Project No. 15-039B

Subject: Addendum No. 1 for Marine Improvements at Oil Dock 2

MARINE IMPROVEMENTS AT OIL DOCK 2

BULKHEAD REPAIR PLAN & DETAILS

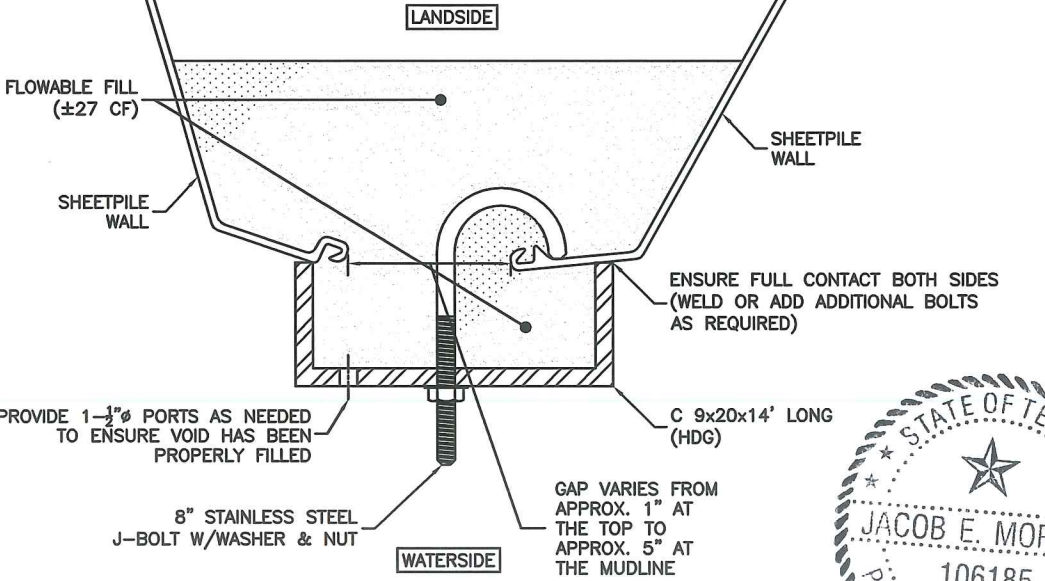
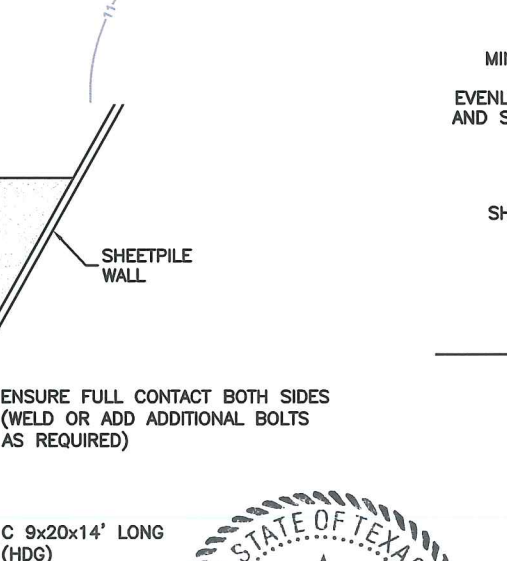
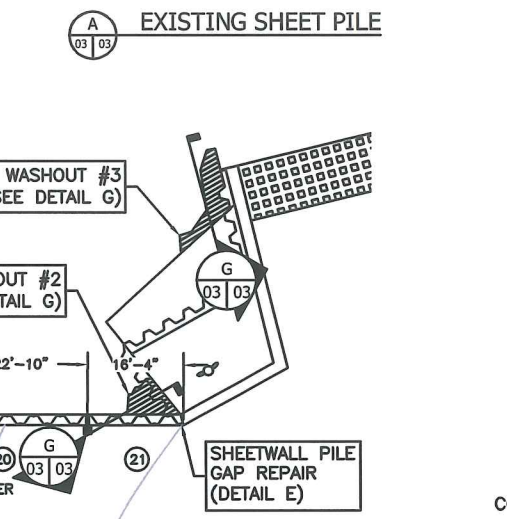
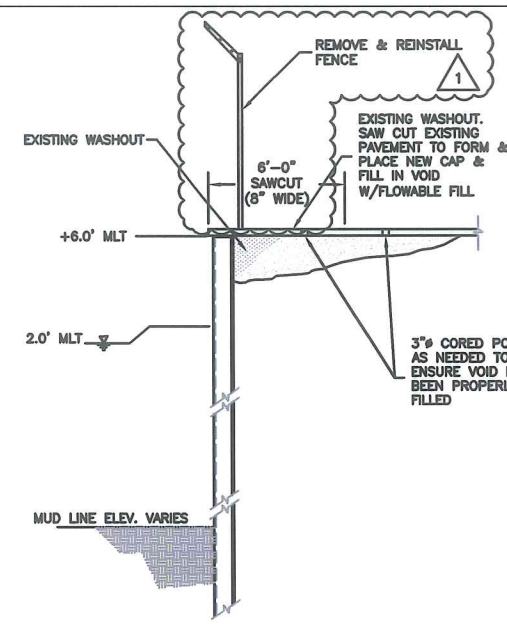
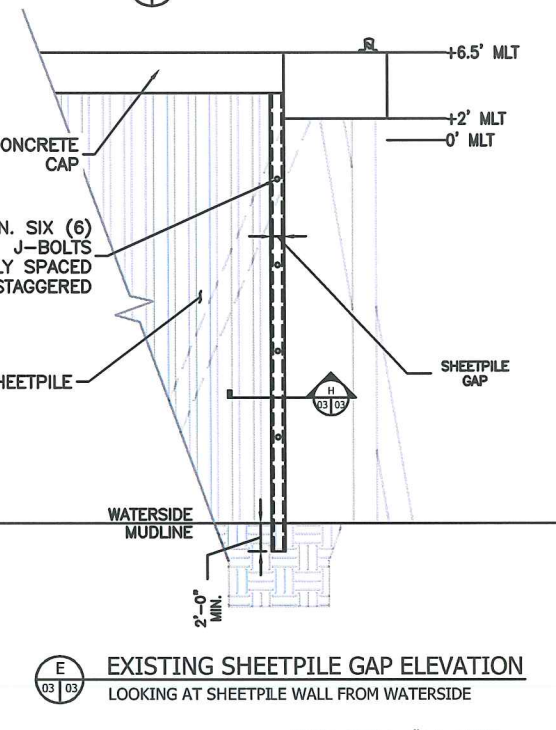
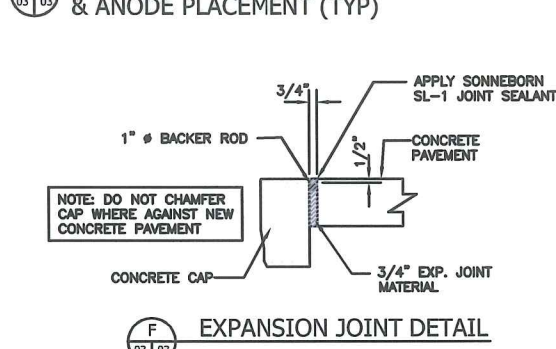
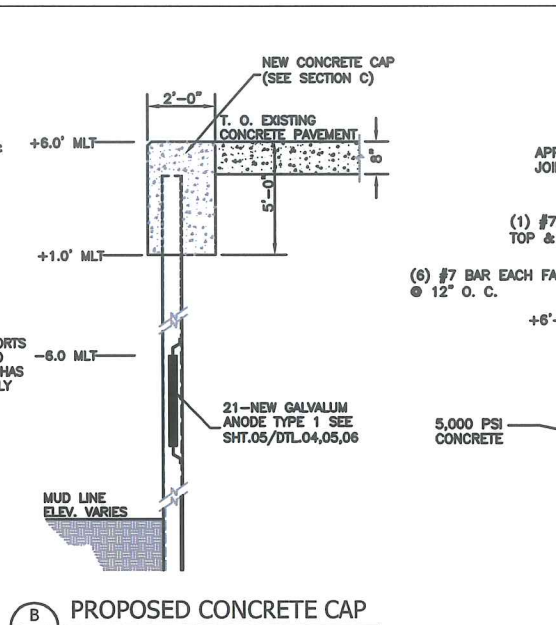
Drawing No. 15-039B-03 BULKHEAD REPAIRS PLAN & DETAIL
